**METROPOLITAN GOVERNMENT OF NASHVILLE AND DAVIDSON COUNTY**

**STAFF RECOMMENDATION**  
**1825 Fourth Avenue North**  
**April 19, 2017**

**Application:** New construction—infill and Outbuilding; Setback determination  
**District:** Salemtown Neighborhood Conservation Zoning Overlay  
**Council District:** 19  
**Map and Parcel Number:** 08108029400  
**Applicant:** Prithvi Gummi  
**Project Lead:** Melissa Baldock, melissa.baldock@nashville.gov

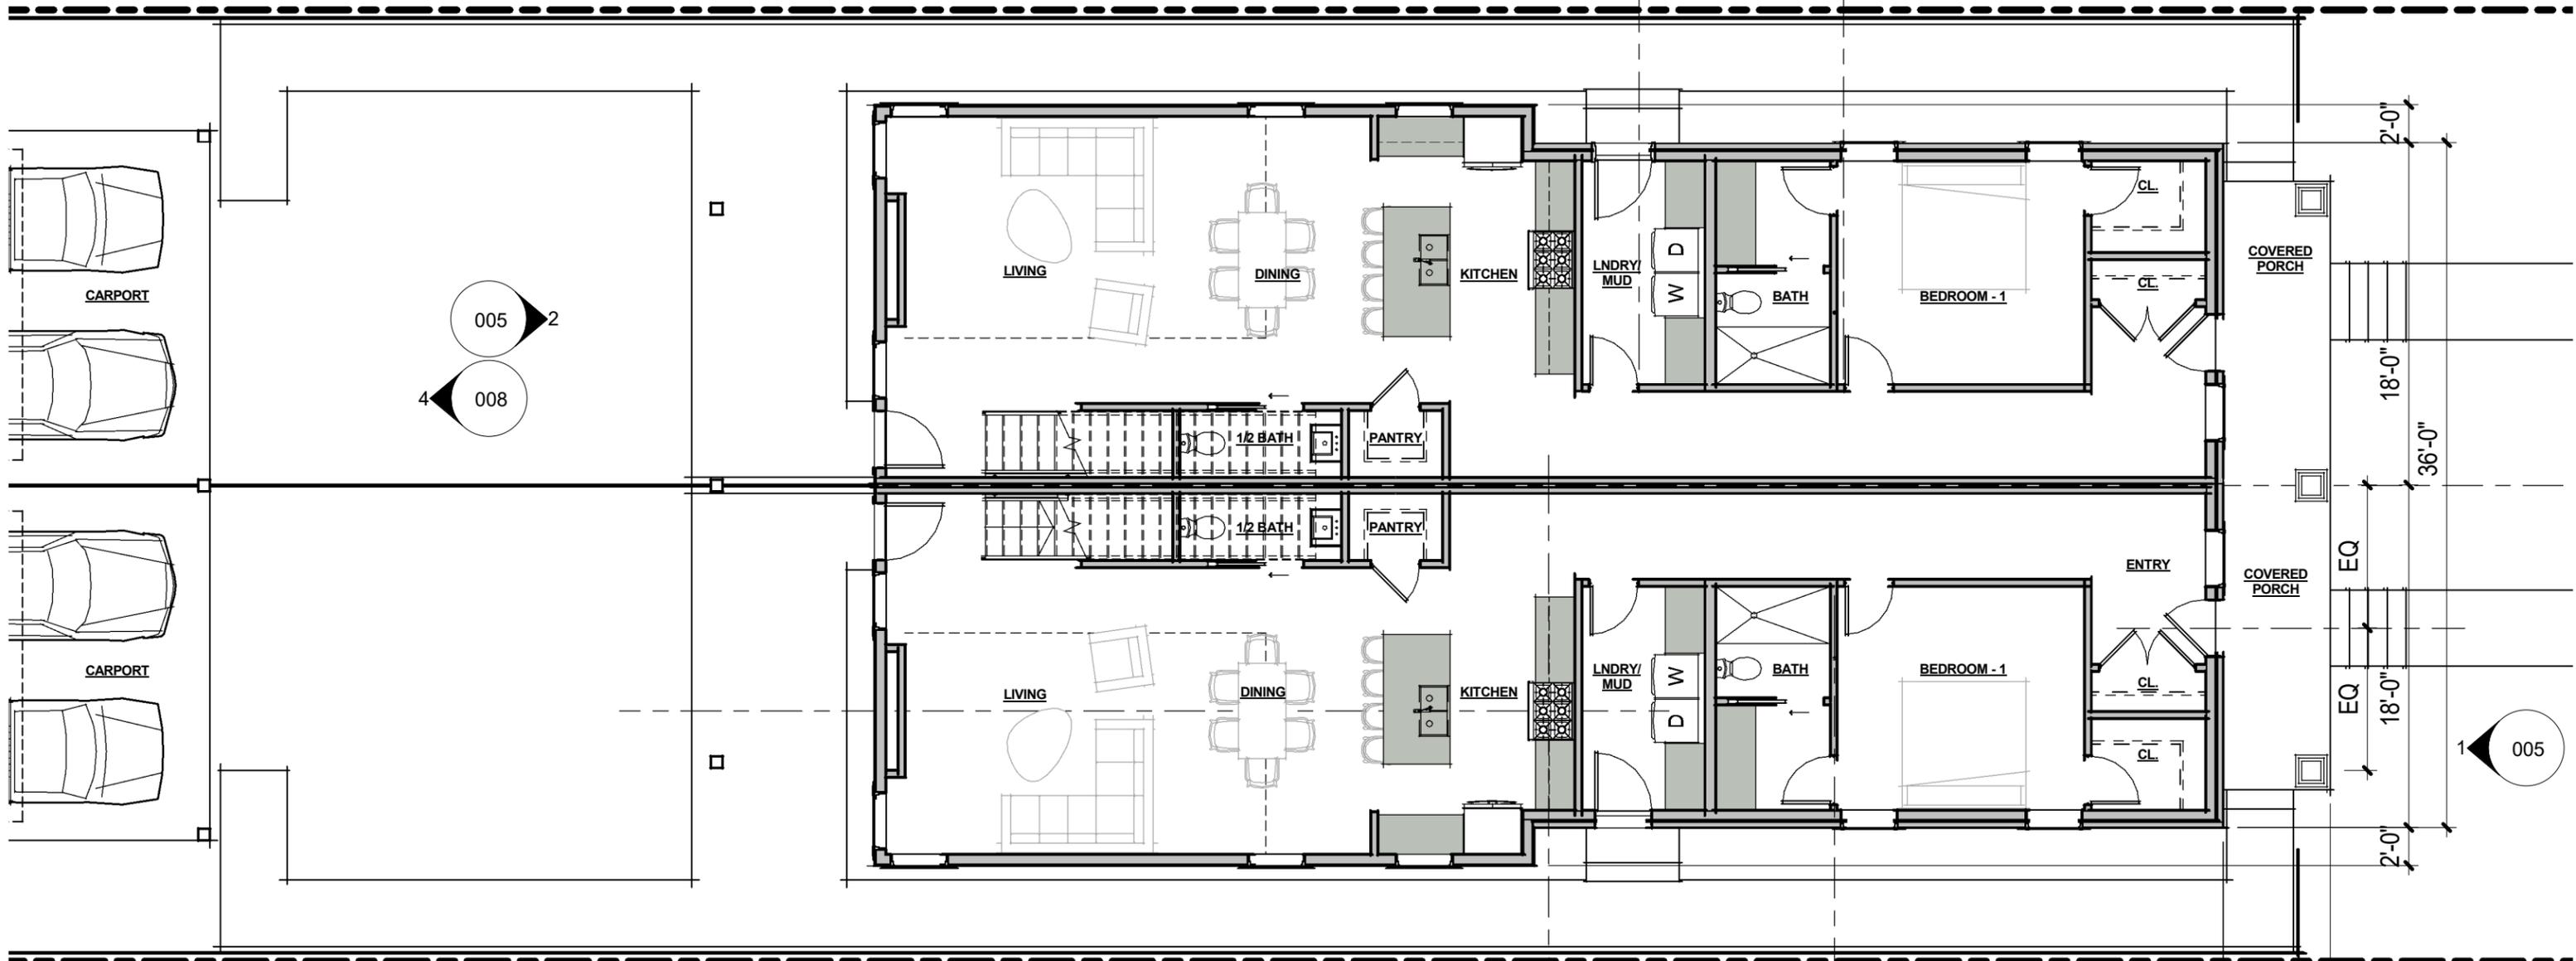
**Setback & Rhythm of Spacing:** The infill meets all base zoning setbacks. It will be a minimum of five feet (5') from the side property lines and approximately sixty feet (60') from the rear property line. The front setback will be the approximate average of the two

\* The proposed outbuilding requires a rear setback determination. Base zoning requires a twenty foot (20') rear setback when an outbuilding's footprint is more than seven hundred square feet (700 sq. ft.). In this case, the outbuilding's footprint is approximately seven hundred and forty-seven square feet (747 sq. ft.). The applicant, however, is proposing to situate the outbuilding just five feet, six inches (5'6") from the rear property line.

Staff finds that the proposed five foot, six inch (5'6") rear setback to be appropriate because historically, outbuildings were situated close to the rear and side property lines. A five foot, six inch (5'6") rear setback is more historically appropriate than a twenty foot (20') rear setback. The reduced rear setback allows for more space in between the house and the outbuilding, which is appropriate. In addition, because the rear property line abuts an alley, the reduced rear setback will not directly affect any adjoining properties. Staff finds that the proposed site planning and setbacks meet Section III.H. of the design guidelines.

**1 EAST ELEVATION**

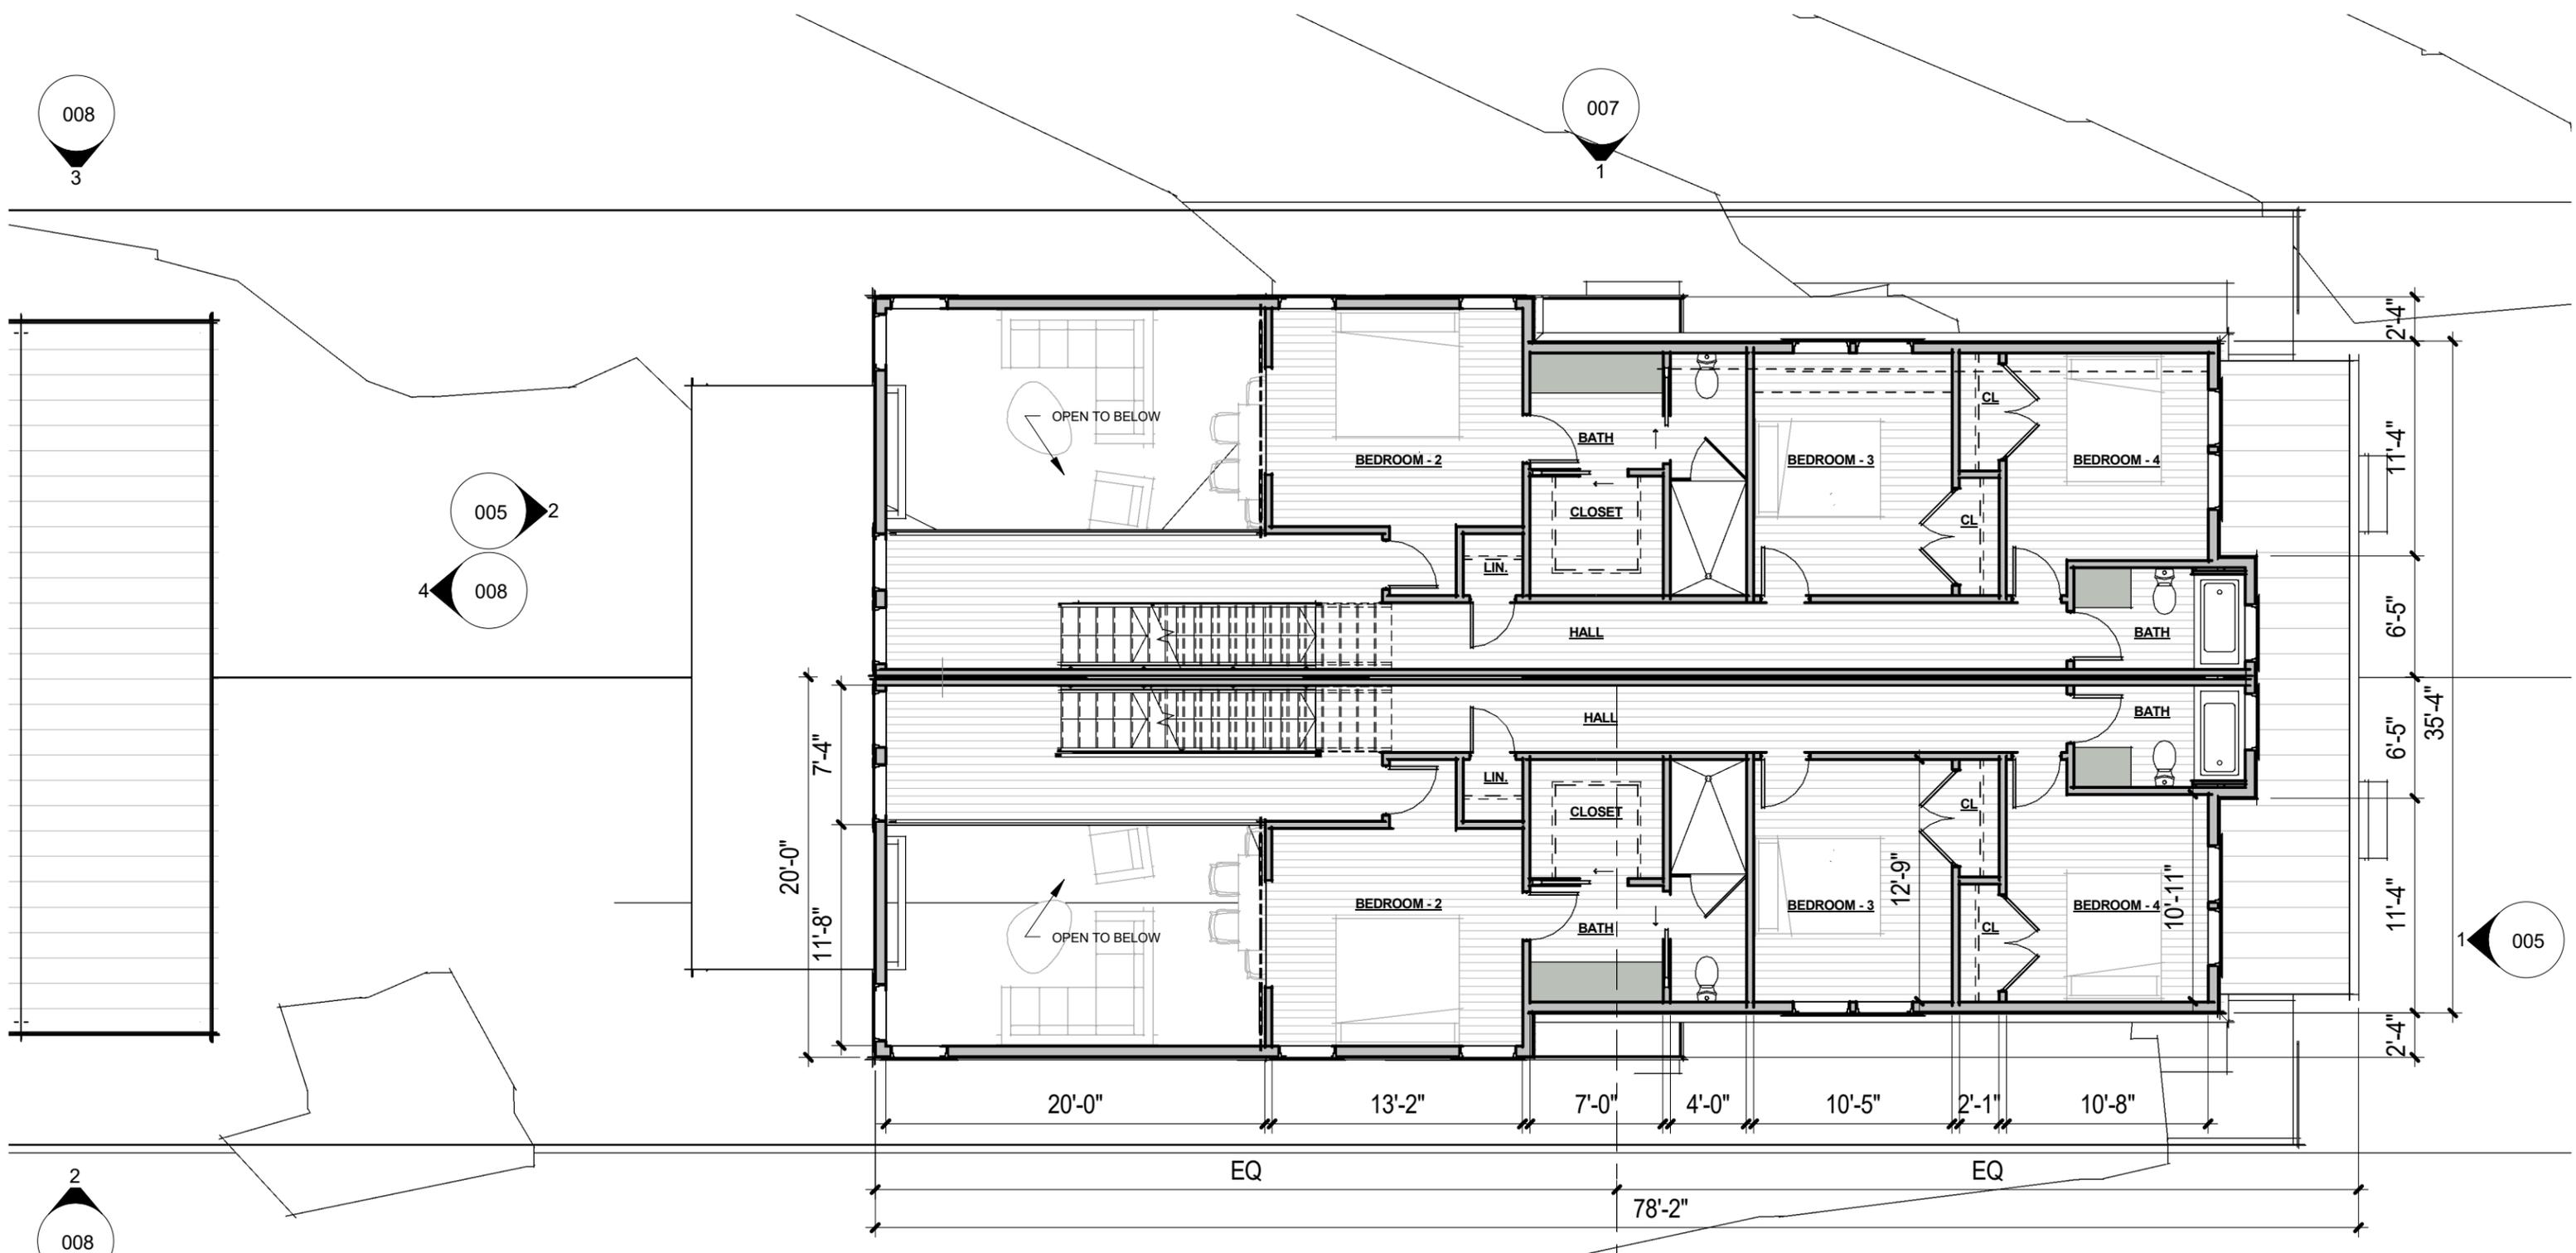
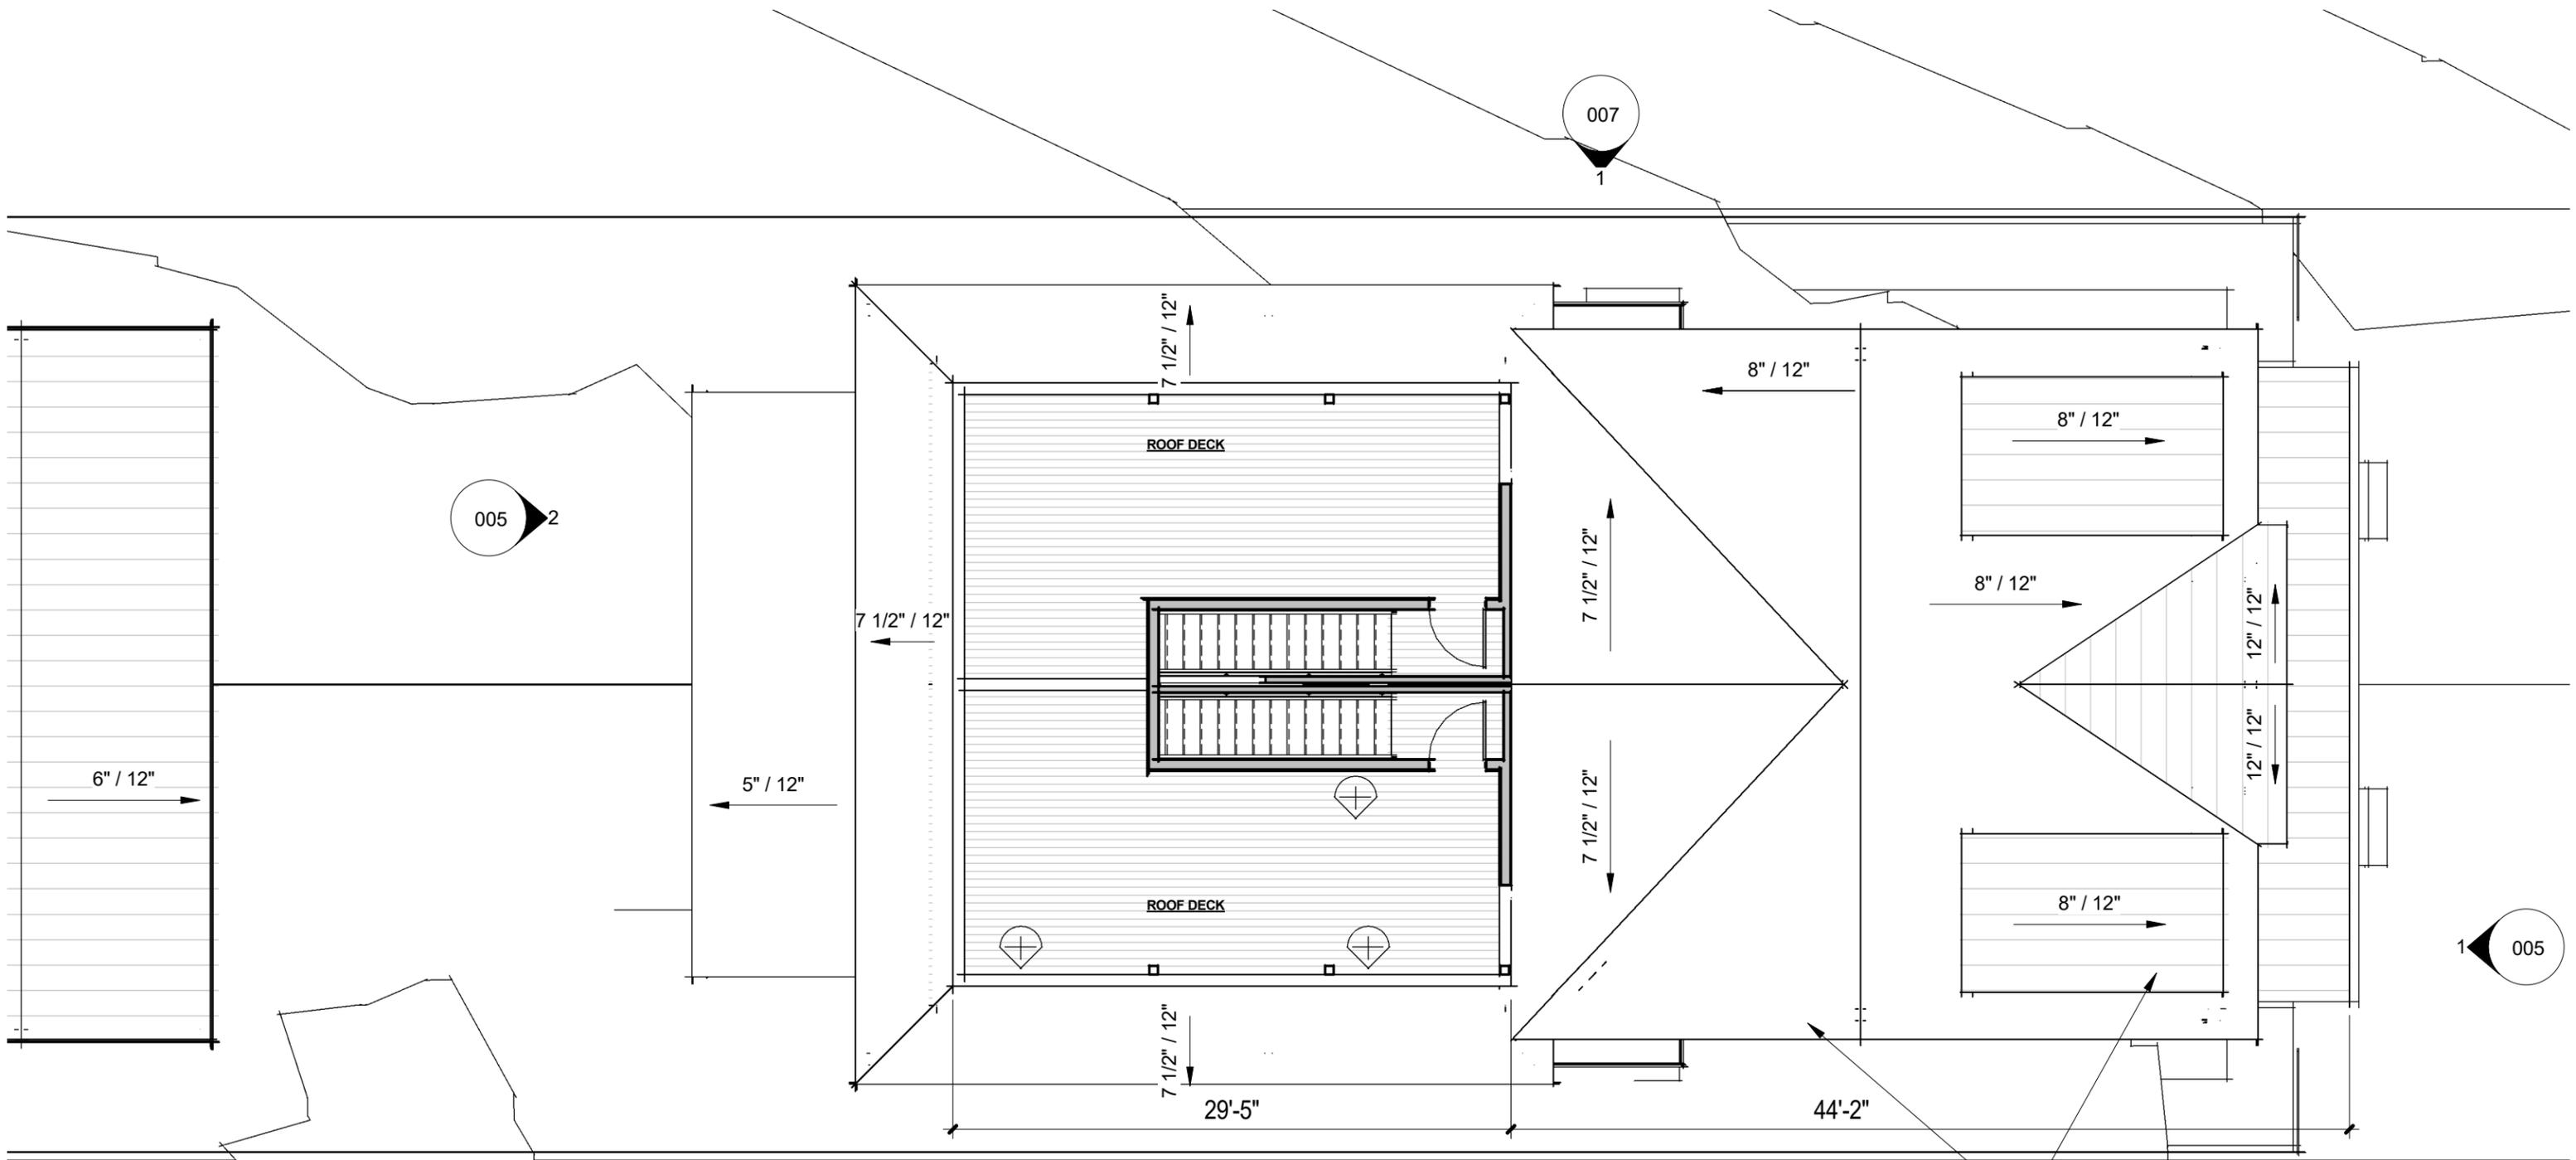
**Height & Scale:** The proposed infill will have a maximum eave height of twenty-one (21') and a maximum ridge height of thirty-four feet, nine inches (34'9"). Staff finds that these heights meet the design guidelines and the neighborhood context. The front dormers give the infill the appearance of a two-and-a-half story house, whereas the historic context is a maximum of two stories. There are no two-and-a-half stories historic houses in the Salemtown Neighborhood Conservation Zoning Overlay and there is only one two-story historic home. All infill development that has been approved by MHZC since the overlay has been two-story or lower. Because the front dormers give the infill a two-and-a-half story form, staff recommends that the front dormers be removed.

\* The drawings do not show corner boards at exposed corners in the areas where cement fiberboard lap siding is installed. Staff recommends that four inch (4") nominal wood

corner boards be installed at the face of each exposed corners in the areas where lap siding is installed.

\*\* Staff recommends that the front porch column posts have a cap and a base.

Roof form: The proposed infill has a side gable roof form with an 8/12 pitch. As mentioned under “Height and Scale,” the front shed dormers give the infill a two-and-a-half story form, and staff therefore recommends that the front dormers be removed. The back half of the infill ties into the back slope of the side gable with a 7/12 gable. The upper portion of the roof is removed at the back in order to create a rooftop terrace above the second story. Since the rooftop terrace is at the back of the house and will not be highly visible from the street, staff finds it to be appropriate. With the removal of the front dormers, staff finds that the project’s roof forms meet Section III.E. of the design guidelines.

Orientation: The duplex will be oriented so that both front doors face 4<sup>th</sup> Avenue North, which is appropriate. There will be two walkways leading from the sidewalk to the front porch. The front porch is drawn as five feet, eight inches (5’8”) deep, and staff recommends that the porch be a minimum of six feet (6’) deep. There will be a four foot (4’) tall railing dividing the porch, which the Commission has approved in the past as long as the divider is no more than four feet (4’) tall. Vehicular access to the site will be via the alley. Staff finds that the infill meets Section III.F. of the design guidelines.

1. The finished floor height be consistent with the finished floor heights of the adjacent historic houses, to be verified by MHZC staff in the field;
2. The front dormers be removed;
3. The front porch be a minimum of six feet (6') deep;
4. All exposed corners have nominal four inch (4") corner boards;
5. The front porch columns have a cap and a base;
6. Staff approve a brick sample;
7. Staff approve the colors of the asphalt shingles and the standing seam metal roofs;
8. Staff approve the final details, dimensions and materials of all windows and doors prior to purchase and installation; and
9. The HVAC be located behind the house or on either side, beyond the mid-point of the house.

① **GARAGE ELEVATION - WEST**

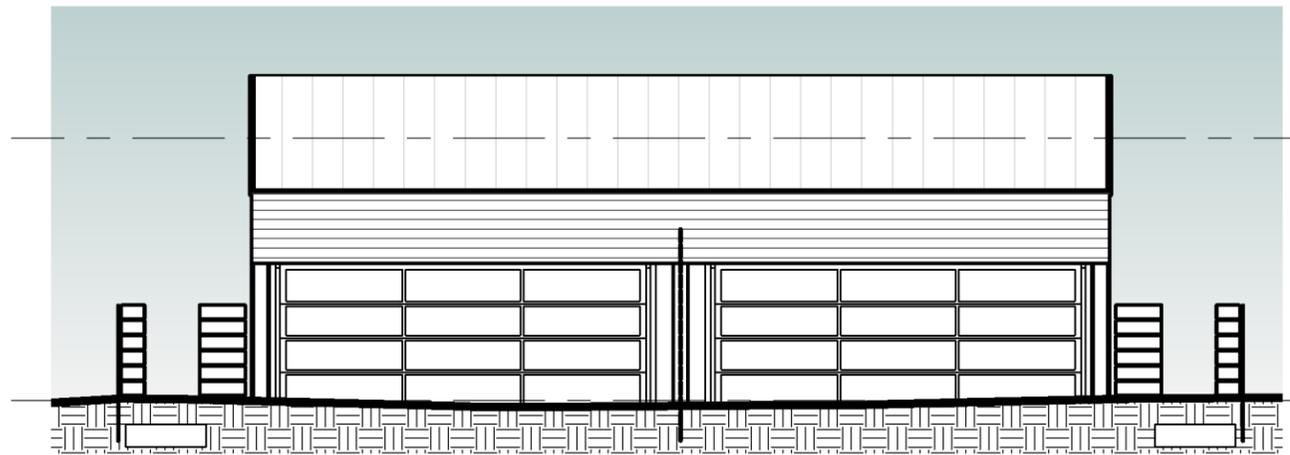
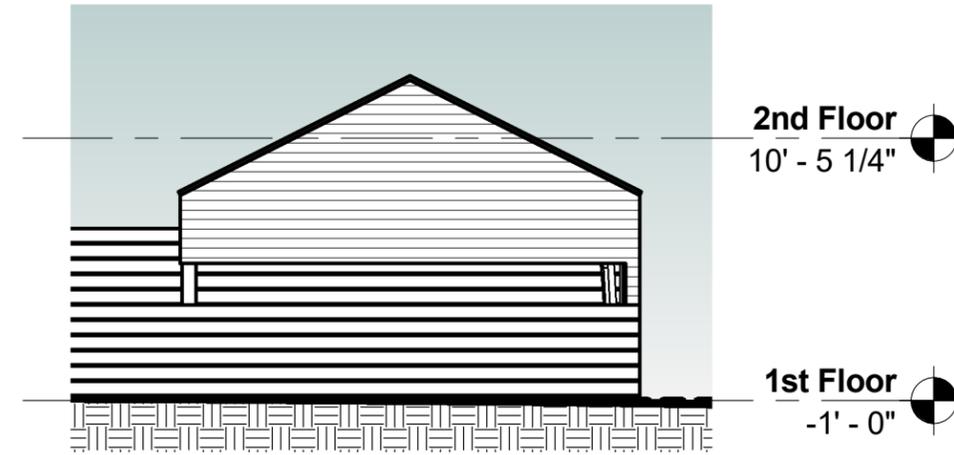
*Design Standards:* The accessory structure has a simple, utilitarian design that is appropriate for outbuildings. The outbuilding will be open on its two sides and will have vehicular doors facing the alley and facing the interior of the lot. The outbuilding’s roof form, detailing, and form do not contrast greatly with the primary structure. It is in a minimally-visible location at the rear of the lot. Staff finds that the outbuilding meets Section III.H.2 of the design guidelines.

With the staff’s final approval of the vehicular doors and the metal roof color, staff finds that the known materials meet Section III.H.4 and 5 of the design guidelines.
